Ohio Department of Transportation

# FRA-161-15.80 Noise Walls – 81” Barrier Drainage Analysis

PID 117607

DOSD/Storm&Sanitary		THE CITY OF <b>COLUMBUS</b> ANDREW J. GINTHER, MAYOR DEPARTMENT OF PUBLIC UTILITIES
<input checked="" type="checkbox"/>	<input type="checkbox"/>	<input type="checkbox"/>
COMMENTS	COMMENTS (COMPLIANCE REVIEW ELIGIBLE)	NO COMMENTS
<b>tlstewart</b>		
SUBMITTAL#	Stage 3	04/29/2024

**SCHEMATIC PLAN WITH 81" BARRIER DRAINAGE AREAS AND SPREAD CALC SUMMARIES**  
 STA. 2122+00.00 TO STA. 2172+00.00

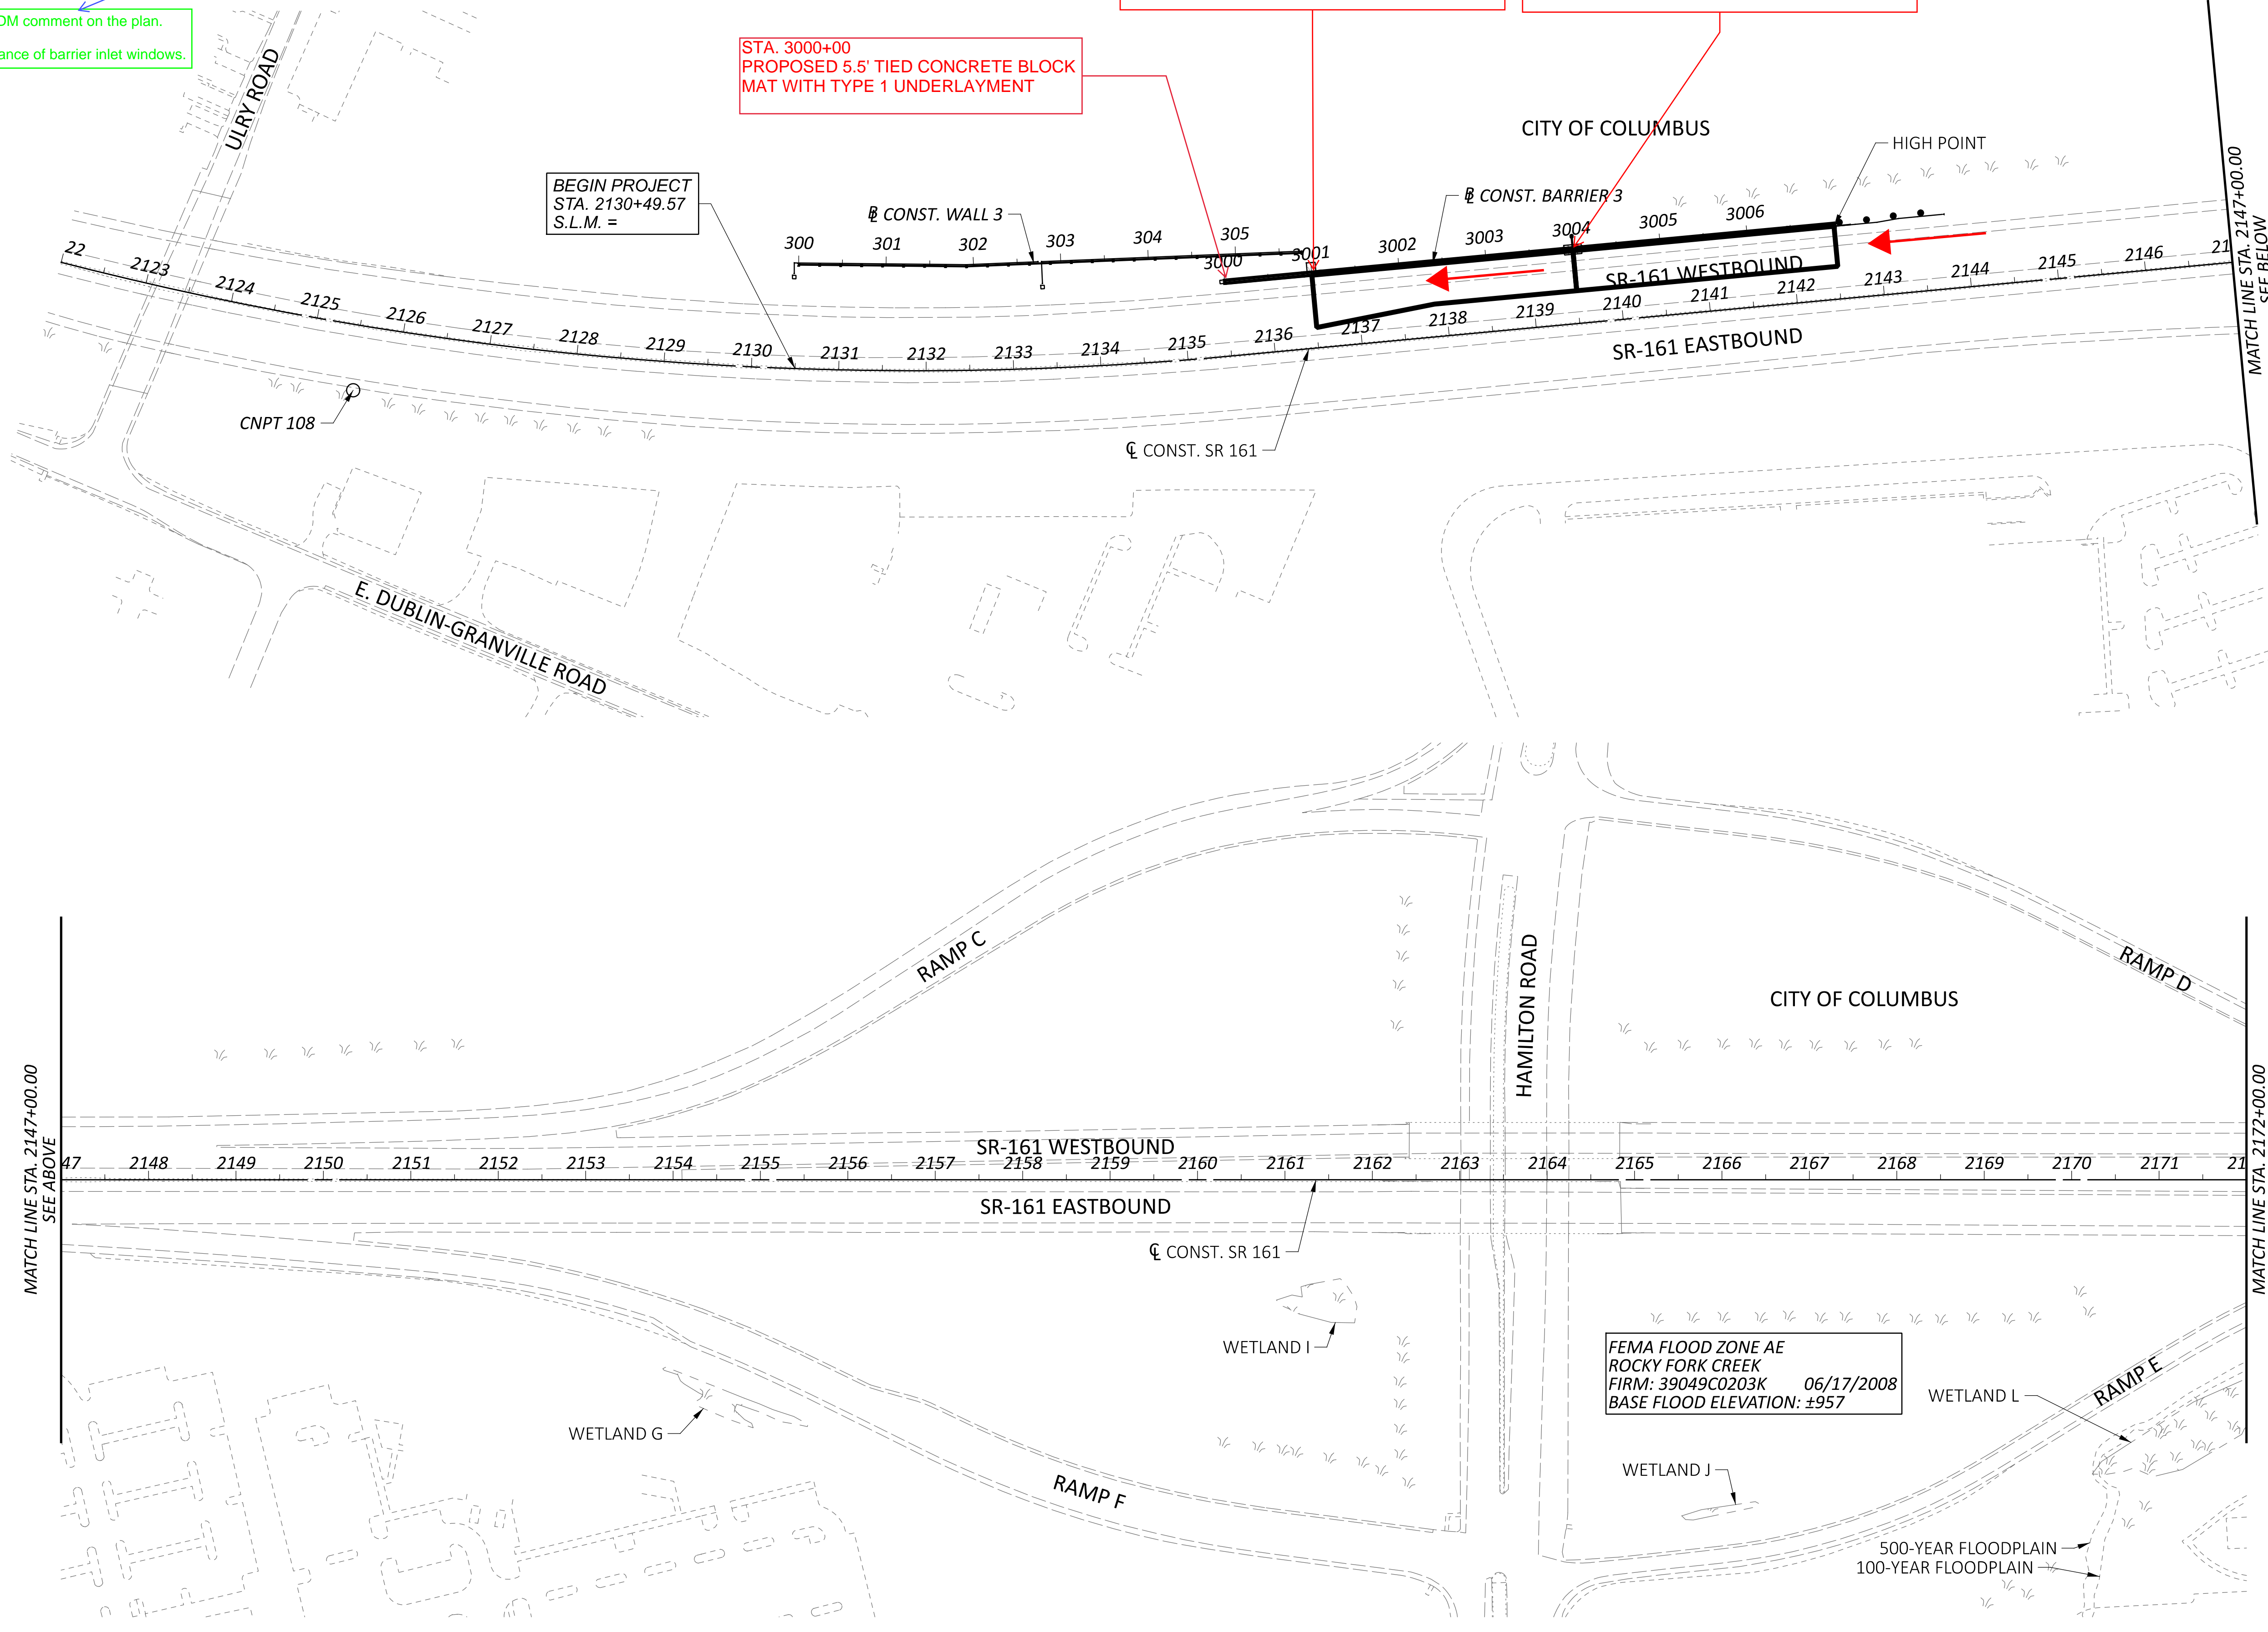
Need to address the SWDM comment on the plan.  
 COC discussing maintenance of barrier inlet windows.

**ARCADIS RESPONSE: COMPLIED PER ODOT DIRECTION. REFER TO THE EMAIL AND MEMO DATED 5/14/24 FROM KATHERINE MONTOYA. PLEASE REFER TO SCOTT LUCAS COC APPROVAL OF ACCEPTING MAINTENANCE RESPONSIBILITY FOR THE BARRIER INLET WINDOW (PDF PAGE 3).**

ARCADIS RESPONSE: COMPLIED PER ODOT DIRECTION. REFER TO THE EMAIL AND MEMO DATED 5/14/24 FROM KATHERINE MONTOYA. PLEASE REFER TO NEXT SHEET FOR COC APPROVAL OF ACCEPTING MAINTENANCE RESPONSIBILITY FOR THE BARRIER INLET WINDOW.
